TECHNICAL SERVICE BULLETIN

TSB # TSB201802

RE: SIDE DUMP LIGHT BOX

INSTRUCTIONS FOR REINFORCING SSD LIGHT BOX

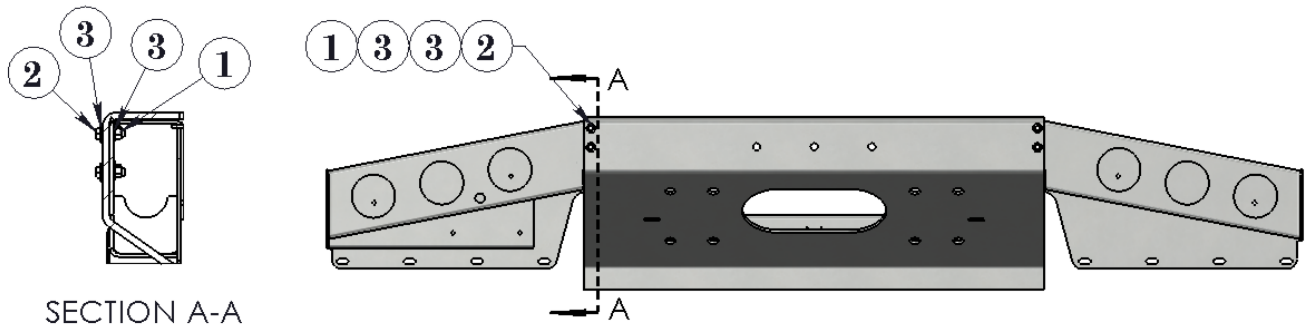
We have identified on some units excessive road vibration may cause cracking in the mounting area of the light box on the Side Dump model trailer. By adding additional bolts to the light box it significantly reduces vibration in this area and fixes the issue.

- Remove inner most tail light and move ALL wiring out of the way to gain access.
- Drill holes through push block mount and first face of light channel. (As shown below)

- Re-install light bracket and install hardware. (As shown below)

- Return all wiring back to original locations.
- Repeat process for other side of trailer.
